Access Compliance Report

Public Rights-of-Way

(Curb Ramps)

Intersection ID: 44467	Main Street: BUCKHORN_ST	Cross Street: ROSBERG_LN	Location: SE
ADA ID: 749B75F2E36A	Ramp Type: Perp	Initial Pass/Fail: Fail	Overall Compliance: No
Severity Score: 8.75			
Codes/Mitigation Info/Possible Solution		Field Measurements/Component Compliance

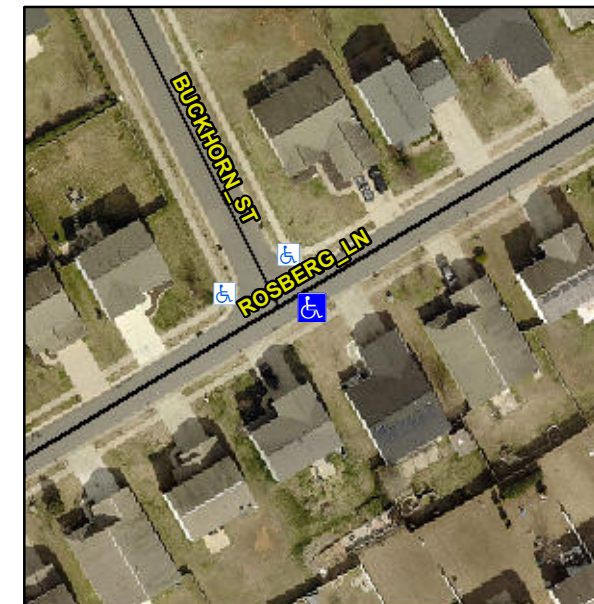
Not Found, R304.5.1

Compliance	Description	Data	Compliance	Description	Data
N/A	Ramp Length (in)	48.0	Yes	Ramp Slope (%)	7.8
No	Ramp Width (in)	45.0	Yes	Ramp XSlope (%)	1.4
N/A	Flare Type LT	N/A	N/A	Flare Type RT	N/A
N/A	Flare Slope LT (%)	N/A	N/A	Flare Slope RT (%)	N/A
N/A	Flare Traversable LT?	N/A	N/A	Flare Traversable RT?	N/A
N/A	Landing Length (in)	N/A	N/A	DWS Provided?	N/A
N/A	Landing Width (in)	N/A	N/A	DWS Contrast?	N/A
N/A	Landing Slope (%)	N/A	N/A	DWS Length (in)	N/A
N/A	Landing X Slope (%)	N/A	N/A	DWS Full Width?	N/A
N/A	Landing Curb? (Y/N)	N/A	N/A	DWS Offset (in)	N/A
N/A	Shared Landing?	N/A			
N/A	Gutter Ponding?	N/A	N/A	Gutter Slope (%)	N/A
N/A	Gutter Lip Ht (in)	N/A	N/A	Gutter X Slope (%)	N/A
N/A	Painted X Walk1?	No	N/A	Painted X Walk2?	N/A
	X Walk 1 Direction	To N		X Walk 2 Direction	N/A
N/A	X Walk 1 Width (in)	N/A	N/A	X Walk 2 Width (in)	N/A
	X Walk 1 Slope (%)	2.5		X Walk 2 Slope (%)	N/A
	X Walk 1 X Slope (%)	1.2		X Walk 2 X Slope (%)	N/A

Remove & Replace Entire Ramp.
